Docket Item # 4 & 5  
BAR CASE # 2011-0121 & 0122

BAR Meeting  
June 1, 2010

**ISSUE:** Permit to Demolish/Encapsulate and Addition (Screened Porch)  
**APPLICANT:** Patricia & James Miller  
**LOCATION:** 821 South Lee Street  
**ZONE:** RM / Residential

Figure 3. Rust on existing iron deck at 821 S Lee Street.

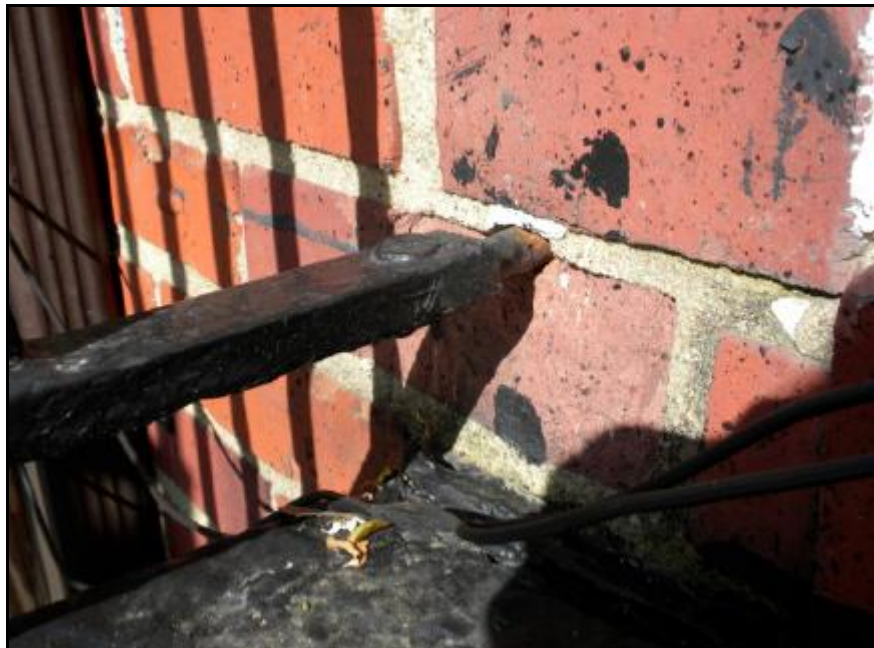
In the opinion of Staff, none of the criteria for demolition and encapsulation are met and the Permit to Demolish/Encapsulate should be granted. The iron deck and stairs proposed for demolition are original, but are on the secondary elevation of a mostly enclosed block. It is not visible from public view due to the number of rowhouses, six foot fences and grade differences on the interior of the block. While the iron deck design is original to the rowhouse, there are many examples of this feature still present on the interior of this block and it is not of unusual or unique construction.

Figure 10. Front and side elevations of proposed screened porch at 821 S Lee Street.

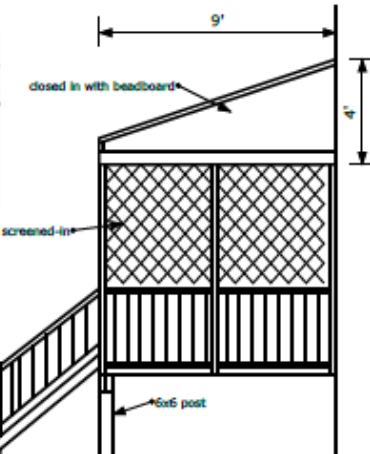
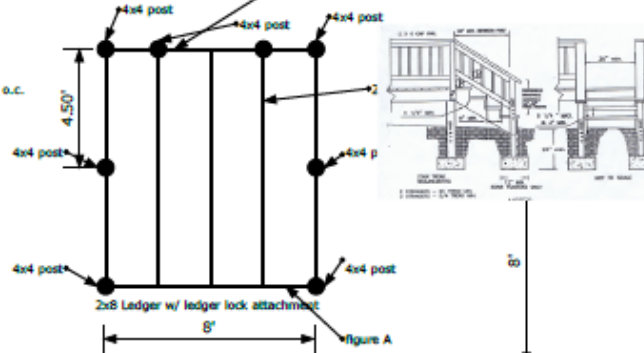
Only the portion of the screen porch above the balustrades will be visible from the public right-of-way. Due to the visibility of the posts and roof structure, Staff recommends that trim molding details be added to the roof edge and posts. The submitted design for the porch is extremely

simple and Staff believes that traditional Colonial Revival vernacular porch characteristics, such as column caps and bases and fascia roof edge trim, etc., should be added in order for the porch to fit the context of the house and surrounding Yates Garden. While a gable roof would provide an additional Colonial Revival detail, Staff supports the shed roof as it matches the roof shape on the remainder of the house and is compatible with the existing shed roof porch next door.

**STAFF RECOMMENDATION:** Staff recommends approval of the Permit to Demolish/Encapsulate and the Certificate of Appropriateness for an addition with the condition that trim detailing be added to the posts and along the roof edge.
